BCA ASSESSMENT REPORT

**PROPOSED WAREHOUSE FACILITY
42 Raymond Ave, Matraville**

Revision 2

Project No.: 210566

Figure 2 – Perimeter Vehicular Access

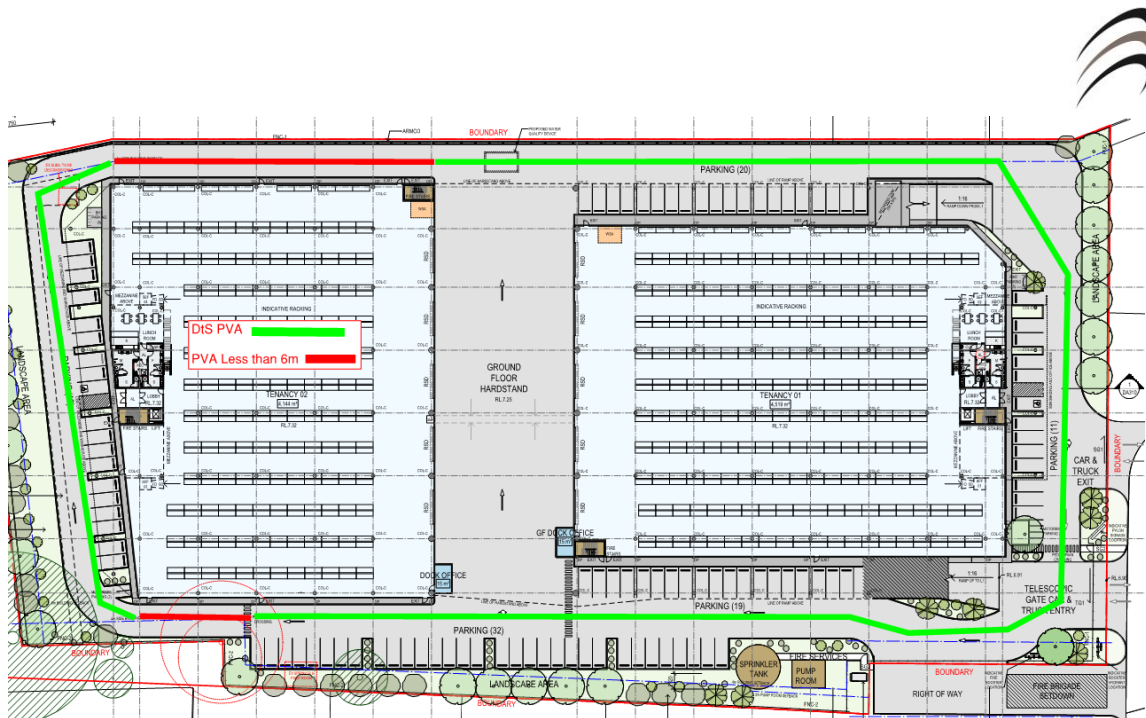
Comments: The perimeter vehicular access is non-compliant with the provisions of this clause in the following areas which are required to be addressed as a Performance Solution by the Fire Safety Engineer (see Appendix 2):

- + Vehicular Access is reduced to less than 6m in width along the western and south-eastern sides (approx. 5.8 clear width measured from kerb to kerb) of Warehouse Tenancy 2- see mark-up below where non-compliances are identified in red.

Note 1: The driveways providing vehicular perimeter access must be designed with adequate loading capacities to withstand a fire truck and the gradients of the ramps should take into consideration to the FRNSW Fire Safety Guideline – Access for Fire Brigade Vehicles and Firefighters.

Note 2: All gates are required to achieve no less than 6m unobstructed width or the reduced width will need to be included in the above Performance Solution.

Figure 3 – Fire Stair discharge paths within 6m of external walls

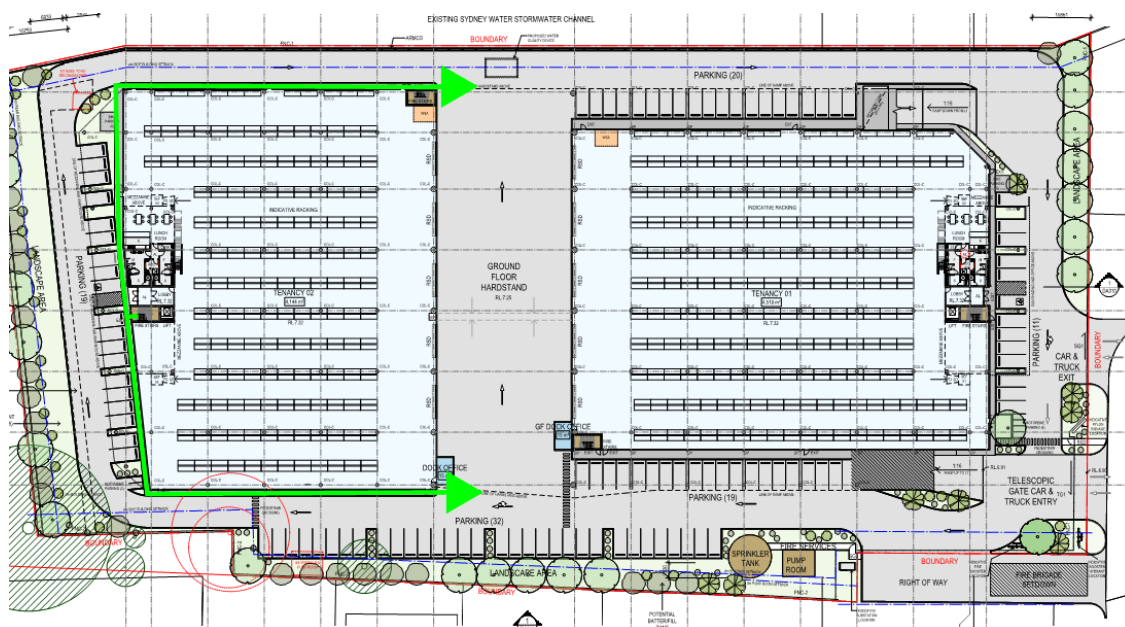
Comments: The discharge of the fire isolated exit serving the office levels comply with the above requirements of D1.7, however, as the discharge paths from the fire stairs serving Office Tenancy 02 & 04 will pass within 6m of the external walls of Warehouse Tenancy 02, either fire rated walls or a Performance Solution will be required.
